BID ADDENDUM NO. 2

Date of Addendum: January 9, 2024
Issued for Bid Date: December 18, 2022
Client Name: Eastchester Union Free School District
Project Name: 2022 Capital Bond Project, Phase 3
SED Project No.: Anne Hutchinson Elementary School: 66-03-01-03-0-001-023
Eastchester Middle / High School: 66-03-01-03-0-003-031
MEMASI Project No.: 102-2301
Contracts: Contract No. 1 – General Construction (GC)
Contract No. 2 – Mechanical Construction (MC)
Contract No. 3 – Electrical Construction (EC)
Contract No. 4 – Plumbing Construction (PC)

**MECHANICAL
DEMOLITION PART
PLAN - SECOND
FLOOR - AREA C**

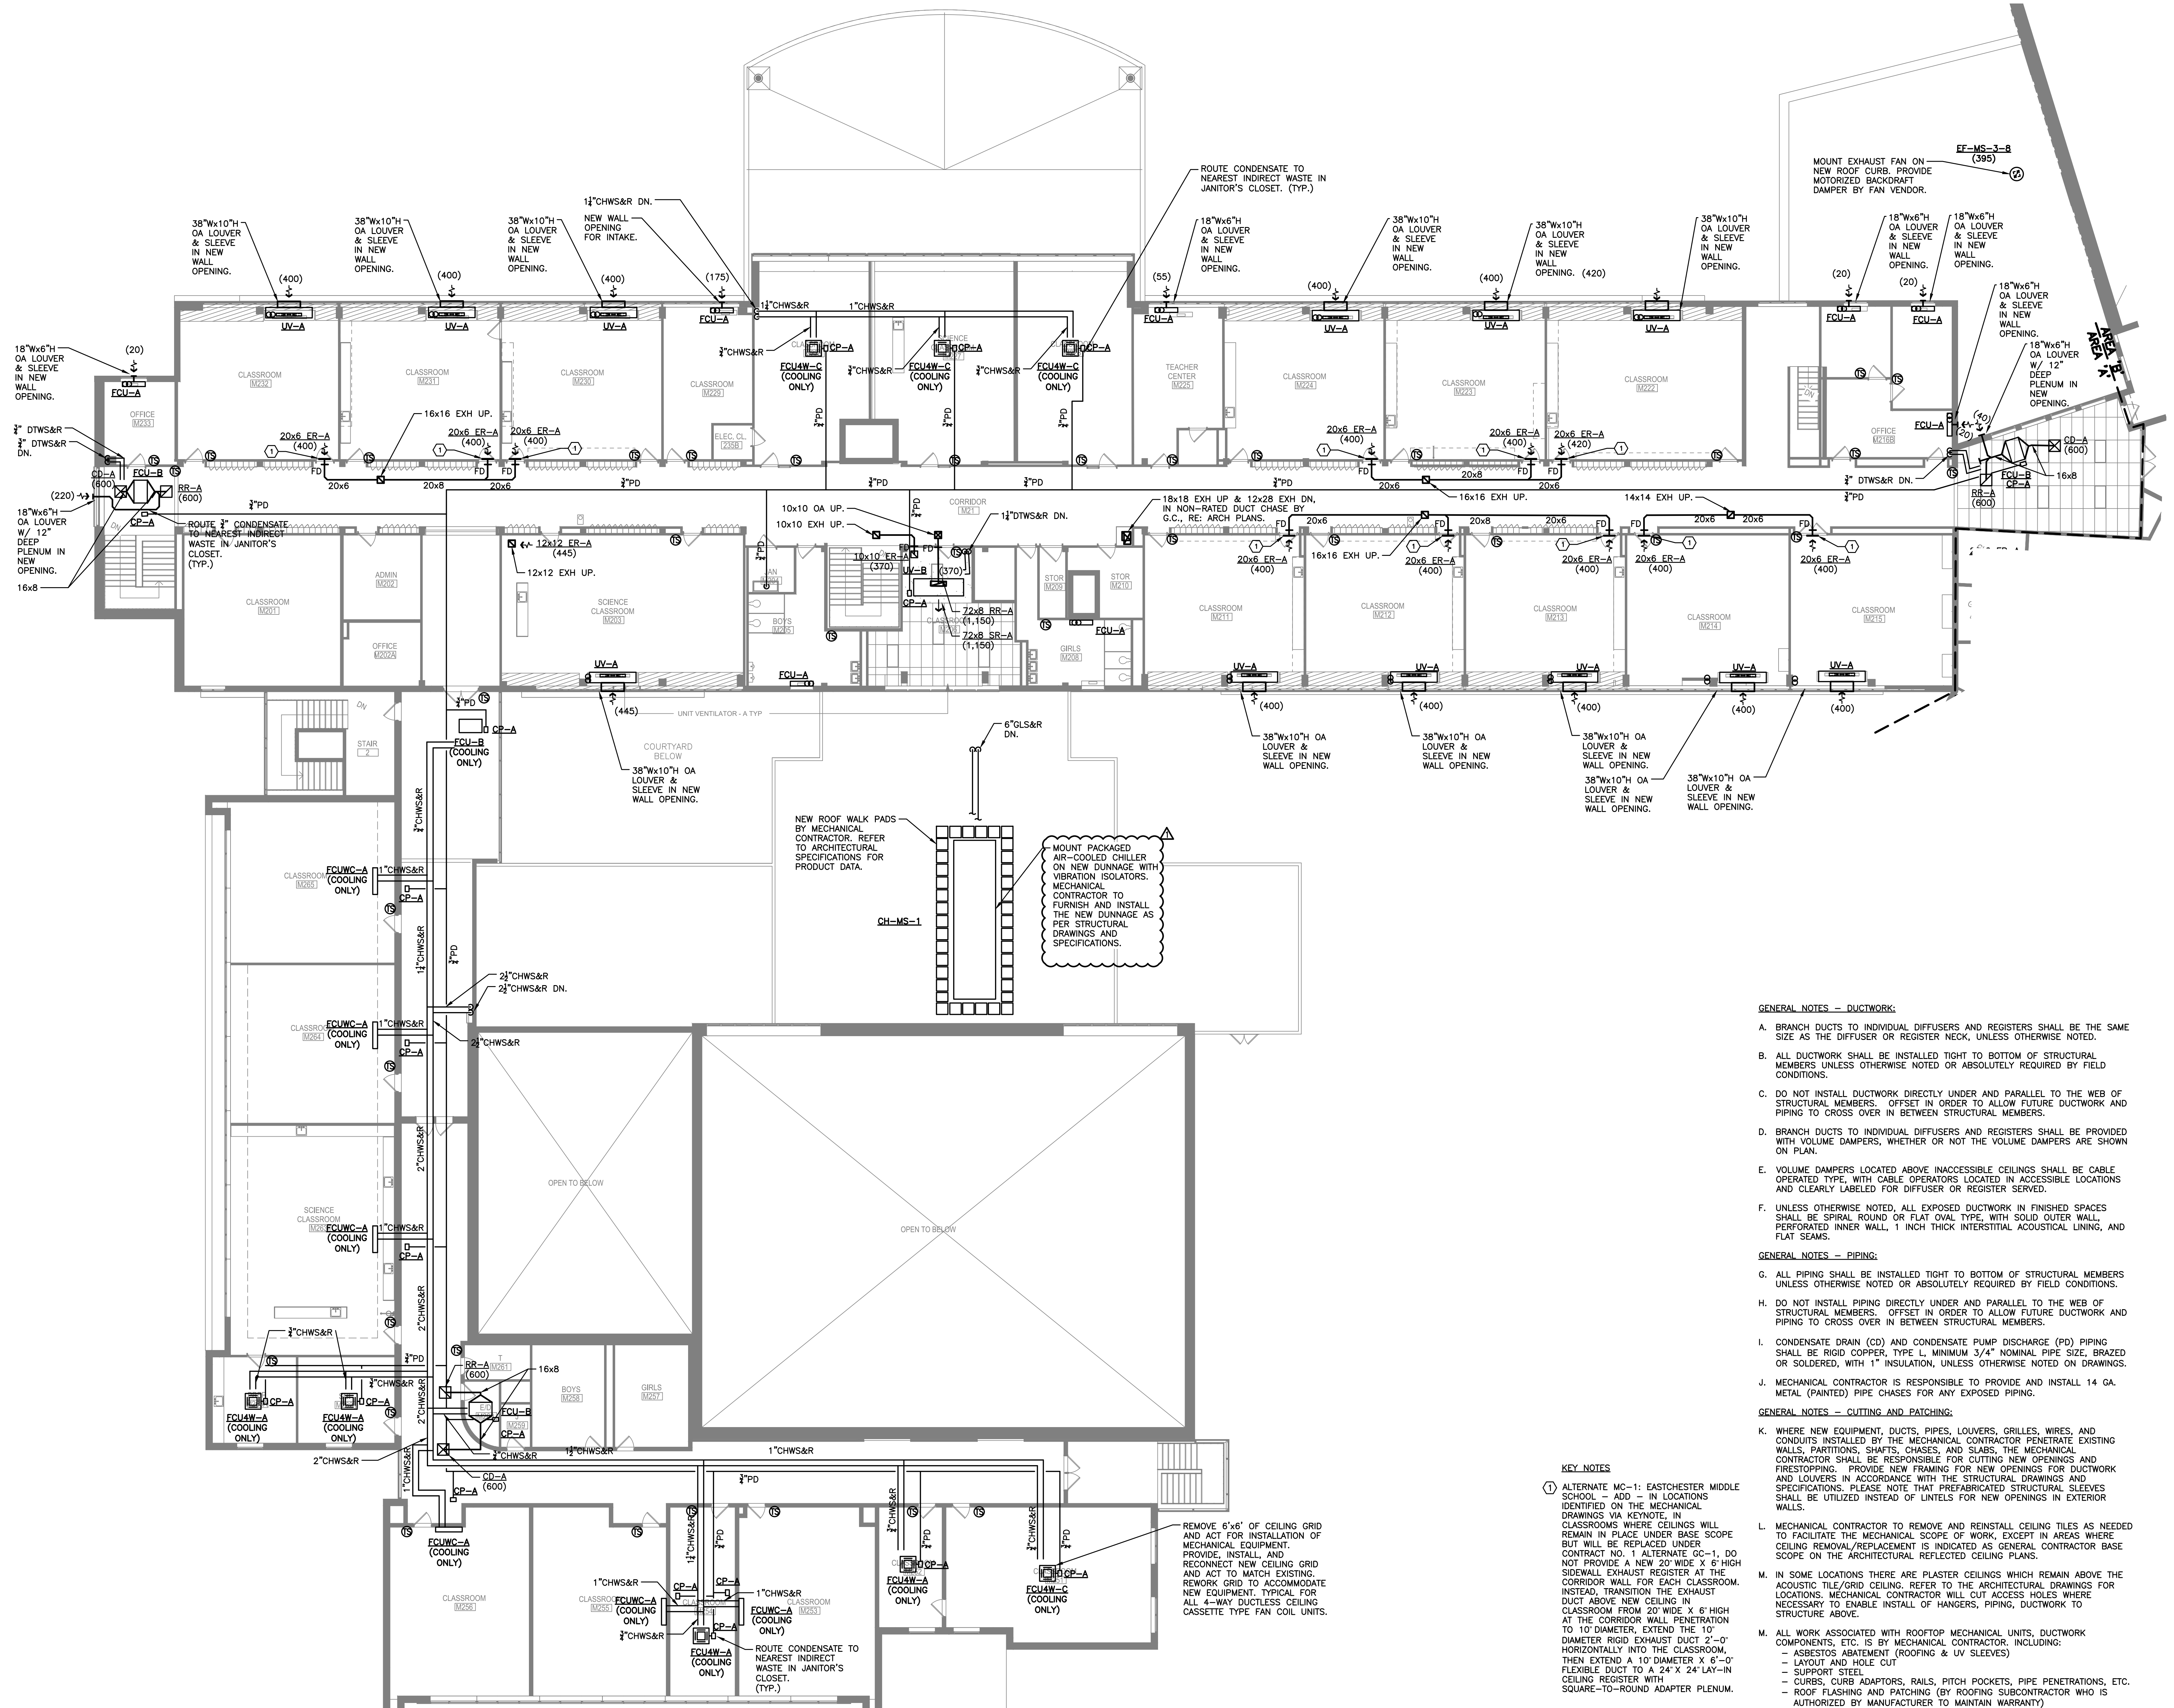
8. HSMS MD102-C – MECHANICAL DEMOLITION PART PLAN -SECOND FLOOR – AREA C

- a. Indicated demolition scope for HS Gym Mechanical room. Demolition of existing H&V units, Return Air fans, and Unit Heater.

**MECHANICAL PART
PLAN - 2ND FLOOR -
AREA A**

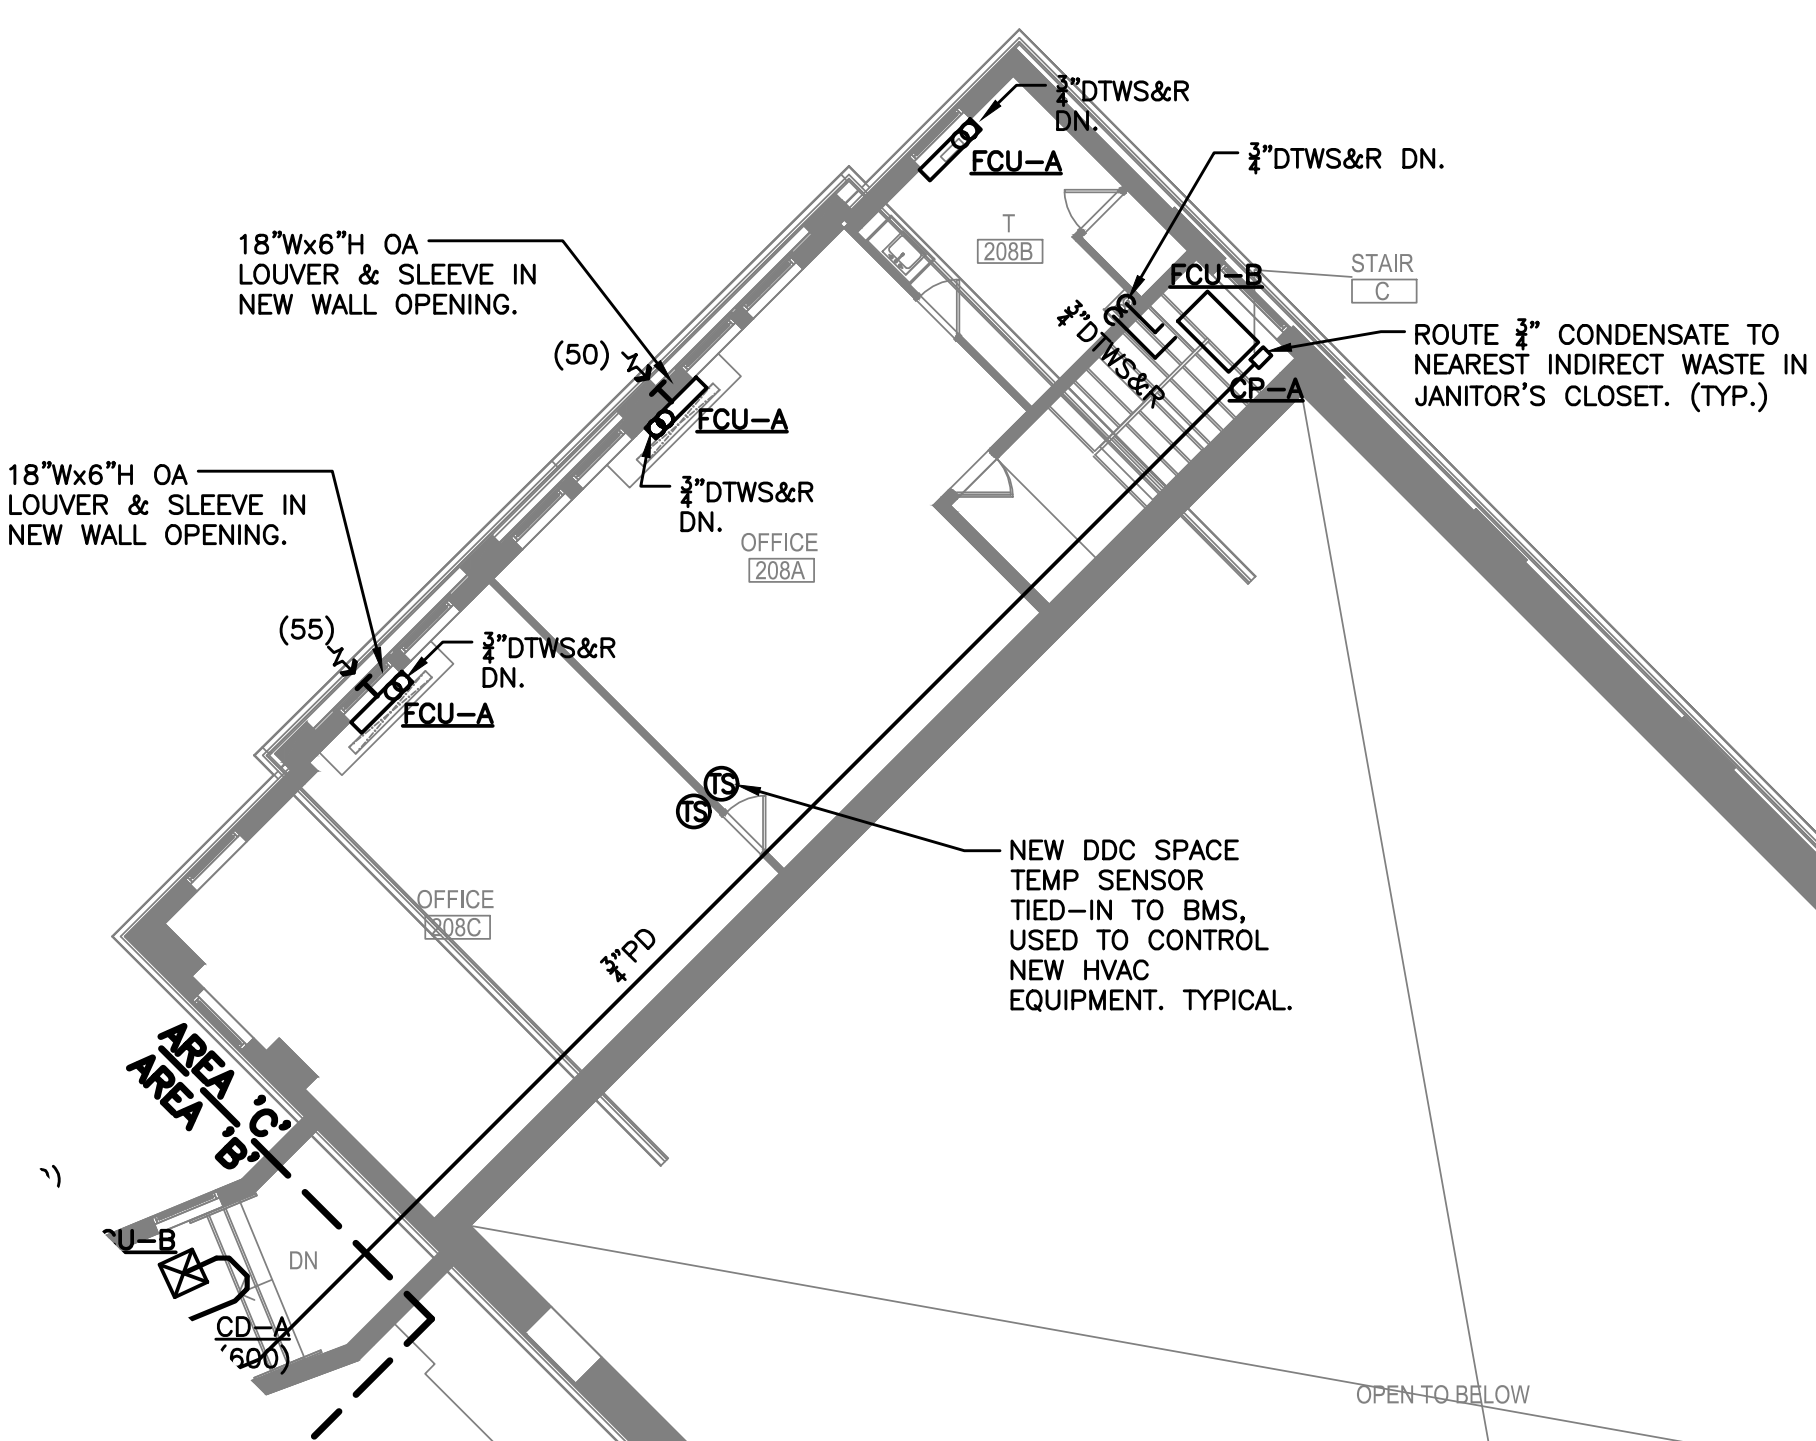
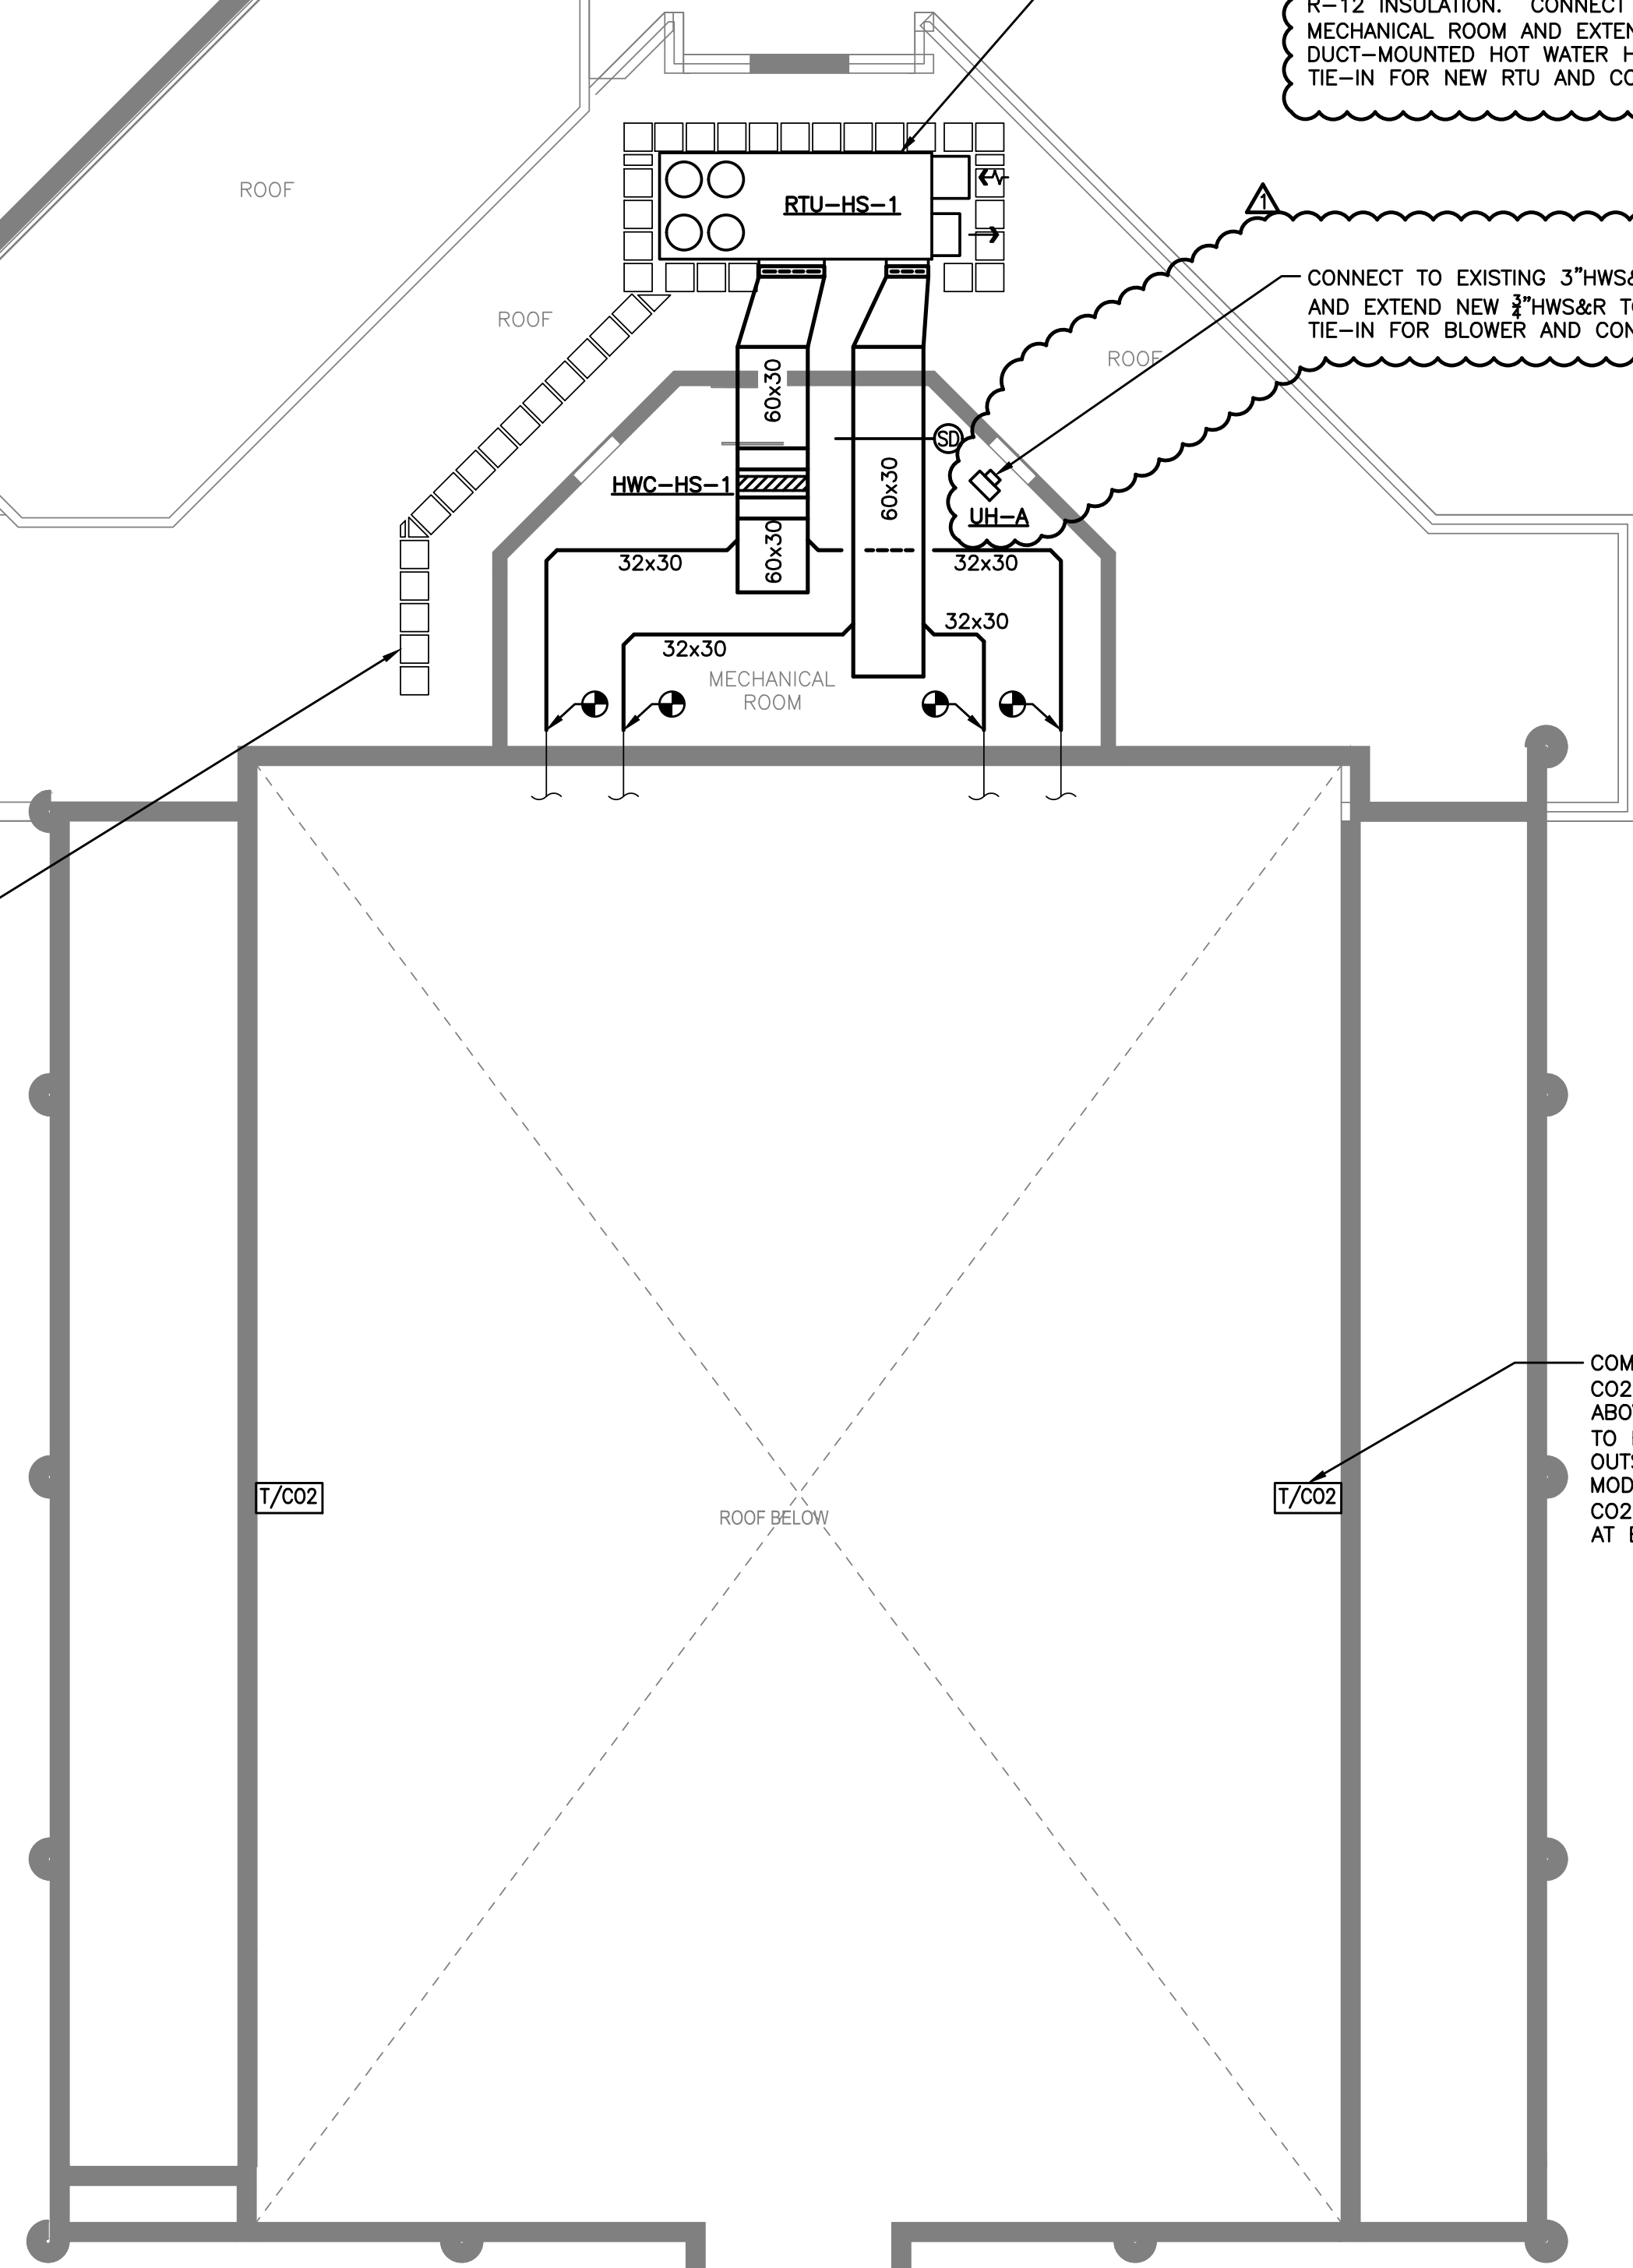
9. HSMS M102-A – MECHANICAL PART PLAN – 2ND FLOOR – AREA A

- a. Chiller note revised to remove dunnage height. Height is indicated on Structural drawings.
- 10. HSMS M102-C – MECHANICAL PART PLAN – 2ND FLOOR – AREA C**
